March 1986

Technical Evaluation Report of
1984 Meteorological Data from
the Donald C. Cook Nuclear
Power Plant

Submitted by: Gregg L. Andrews
Battelle Pacific Northwest Laboratories
P.O. Box 999
Richland, WA 99352

Figure 6

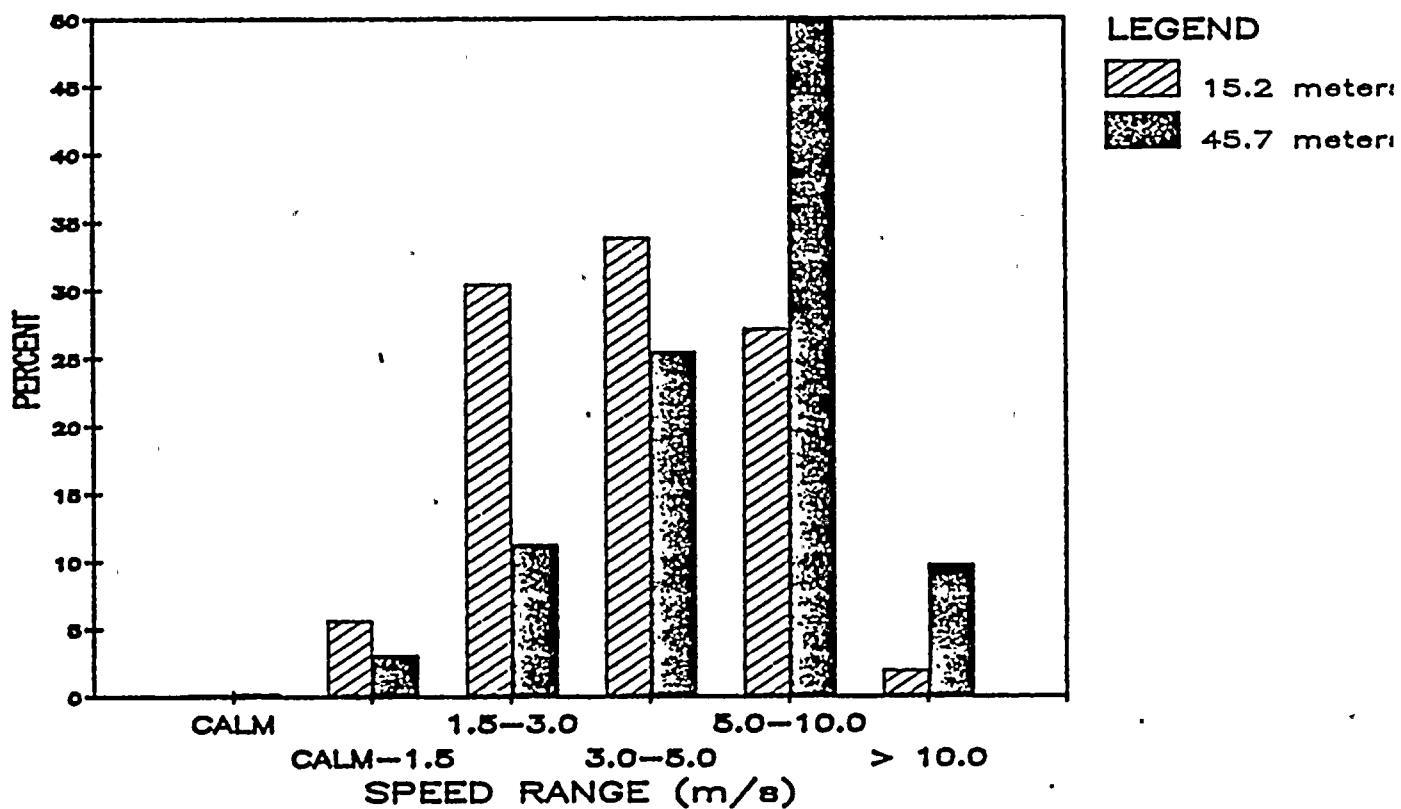
The 1984 D. C. Cook 45.7 meter wind speed was compared with the corresponding 15.2 meter wind speed (Fig. 6). The comparison shows the expected distribution between lower and upper level wind speeds; the lower level is skewed more toward lower wind speeds while the upper level is skewed more toward higher wind speeds. However, there appears to be a rather large increase between the two levels in the 5.0-10.0 m/s speed range. This phenomenon is most likely due to increased frictional affects at lower levels which are probably caused by the sand dune environment and building wakes. The 45.7 meter wind speed

Figure 7

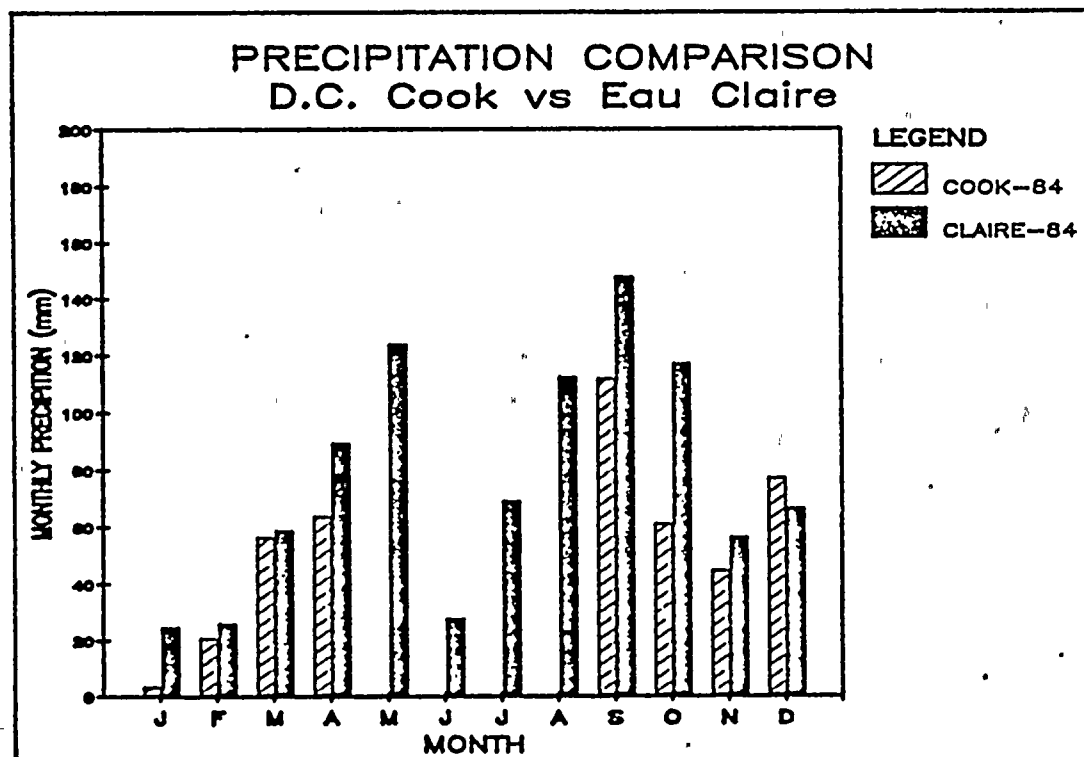
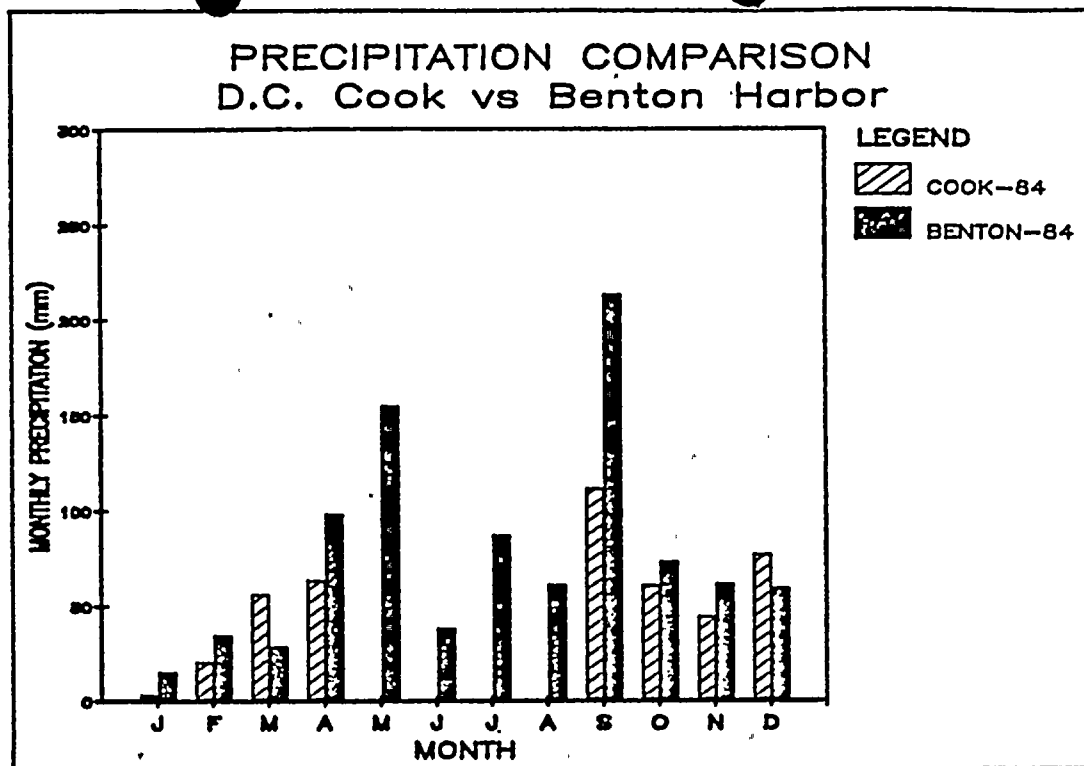
The 1984 D. C. Cook one meter monthly average precipitation data were compared with corresponding precipitation data from Benton Harbor and Eau Claire (Fig. 7). The months of May, June, July, and August do not show monthly averages for D. C. Cook because of missing data. Both comparisons show the D. C. Cook monthly averages are generally lower than the other monthly averages. It can not be determined if the 1984 D. C. Cook precipitation data is representative because a third (four months) of the data are missing and precipitation can vary widely on a local scale. Even if the data were representative it would not be reliable due to its low data recovery (65.5%). It appears the precipitation system is poorly maintained and probably would not be reliable during emergency response situations or routine dose calculations.

Figure 8

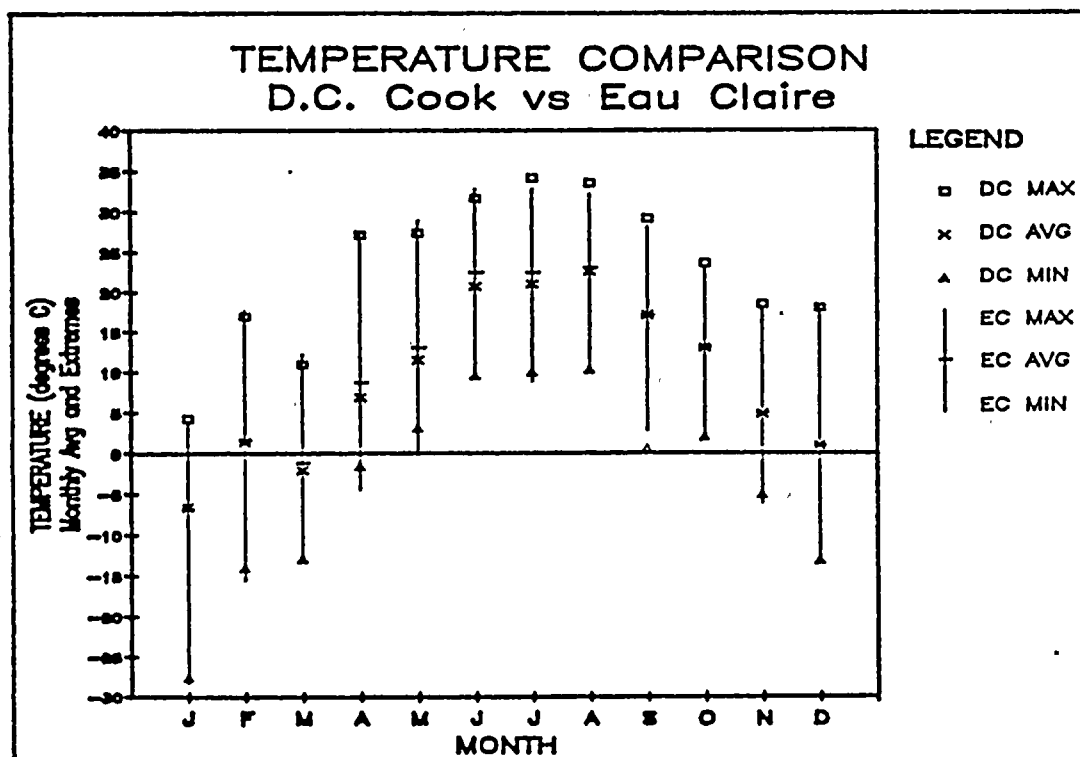
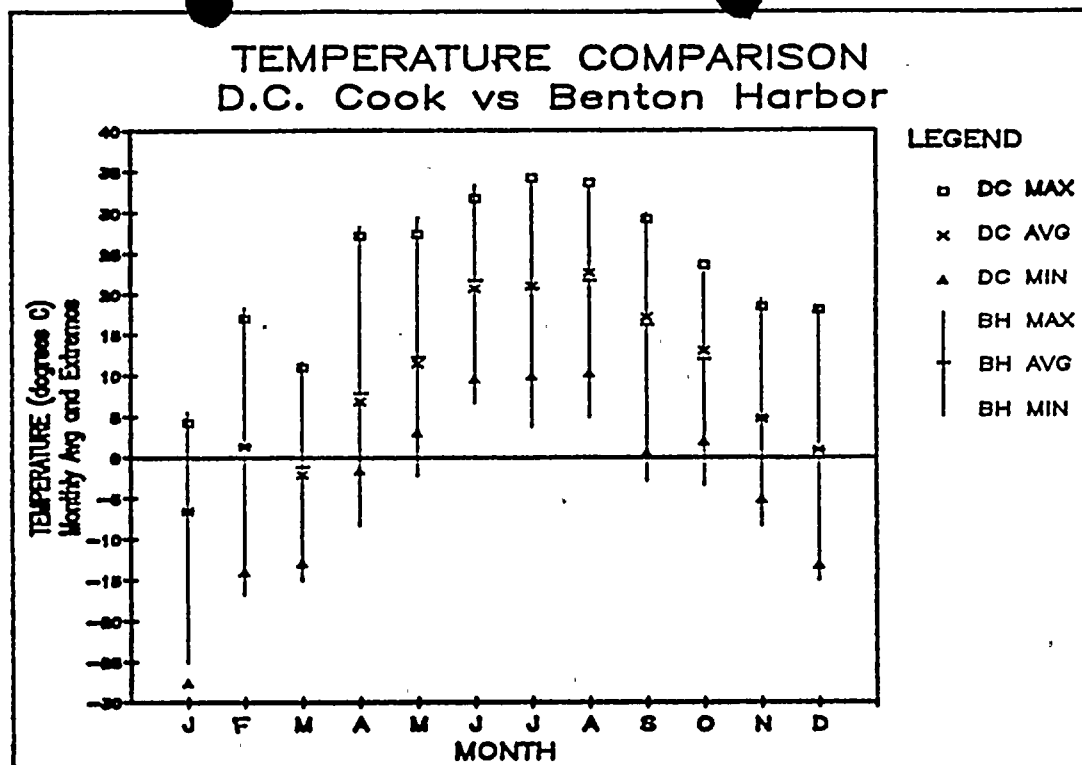
The 1984 D. C. Cook 15.2 meter monthly average and extreme temperature data were compared with corresponding temperature data from Benton Harbor and Eau Claire (Fig. 8). Both comparisons show a close relationship between the monthly average and extreme temperature data. It appears the 15.2 meter temperature data is climatologically representative and are reliable as reflected in its
